W3F1-2003-0045
A4.05
PR

Subject: Waterford 3 SES
Docket No. 50-382
License No. NPF-38
Emergency Plan Implementing Procedures

Emergency Plan Implementing Procedures

REMP SAMPLE LOCATION TABLE

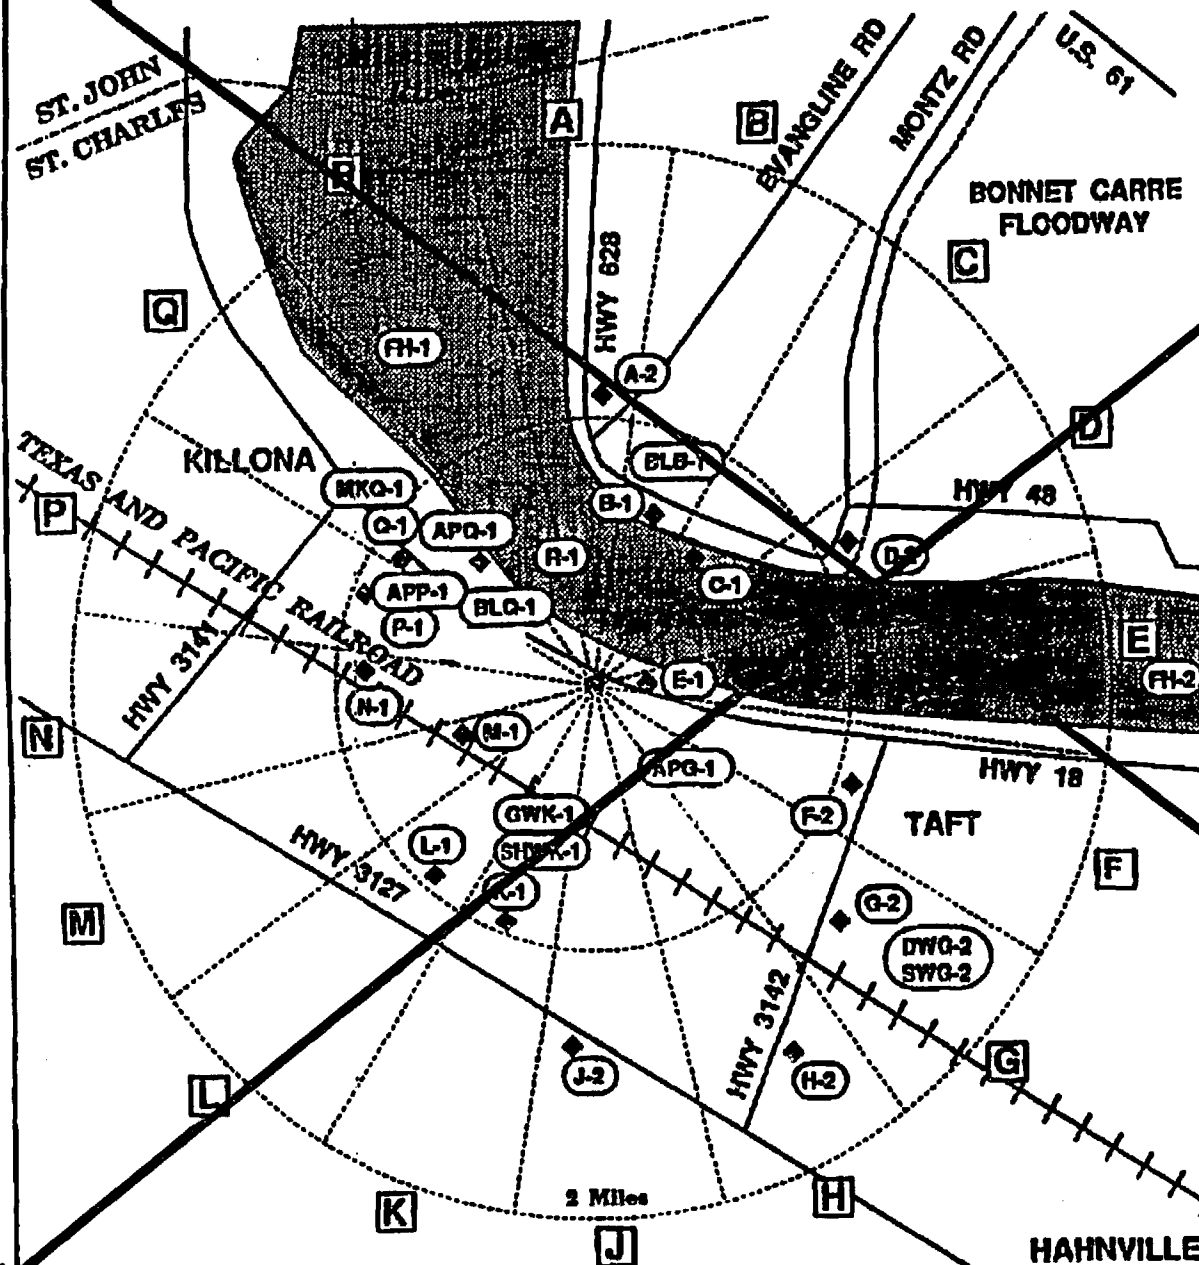
DESCRIPTION AND JUSTIFICATION OF CHANGE: Delete reference to procedures HP-002-351 (automatic TLD reader operation) and HP-002-353 (manual TLD reader operation) because Health Physics no longer uses the manual reader and the automatic reader operation information is contained in HP-001-221. Add HP-001-221 to reference section. Delete attachments (7.5-7.8) that are duplicates of the information contained in the ODCM (UNT-005-014) to prevent information discrepancies.

- 7.1 Emergency Survey Points (Map) - 914 Meter Exclusion Area Boundary
- 7.2 Emergency Survey Points (Description) - 914 Meter Exclusion Area Boundary
- 7.3 Emergency Planning Zone (Map) - 10 Miles
- 7.4 Emergency Survey Points (Description) - 10 Miles
- ~~7.5 REMP Sample Location Table (Description)~~
- ~~7.6 REMP Sample Locations Within 2 Miles of Waterford 3 (Map)~~
- ~~7.7 REMP Sample Locations Within 10 Miles of Waterford 3 (Map)~~
- ~~7.8 REMP Sample Locations Within 50 Miles of Waterford 3 (Map)~~
